CONTINUING ELIGIBILITY INSPECTION (CEI) REPORT
FOR FLOOD CONTROL PROJECTS

1. Project Name: Hanapepe Stream FCP

2. Date of Inspection: December 4, 2001

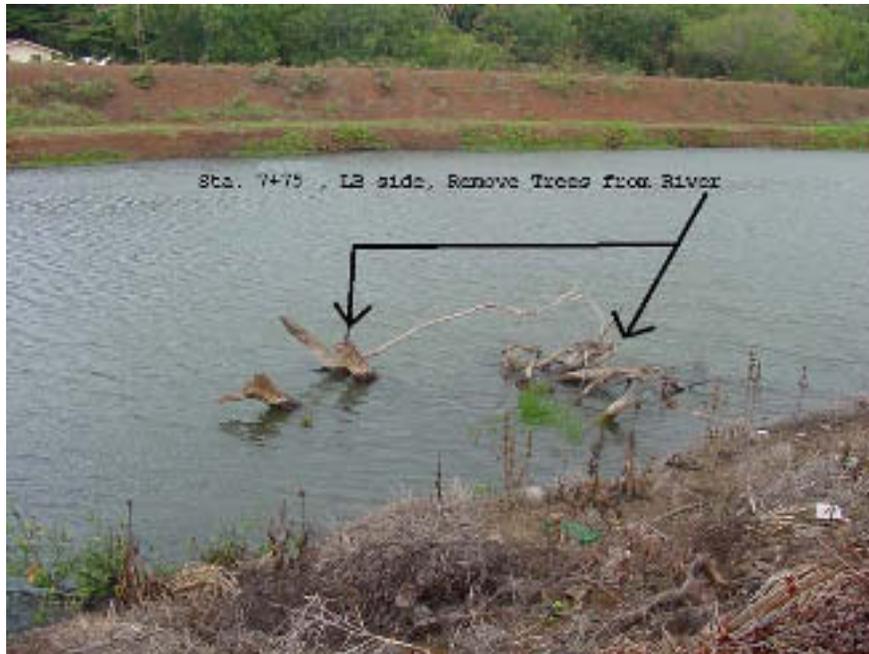
a. Sta. 3+75, LB, Replace inoperable flapgate (®).

b. Sta. 3+95, LB, continue vegetation control on the levee sideslope (®).

c. Sta. 5+50, LB, Inventory levee fence and replace rusted hardware (®).

d. Sta. 7+75, LB side of river, remove vegetation & trees from river.

e. Sta. 7+95, LB, remove stockpile of cut vegetation from levee sideslope.

f. Sta. 7+95, LB, Remove encroachments, restore drainage ditch and restore terraced levee sideslope (®).
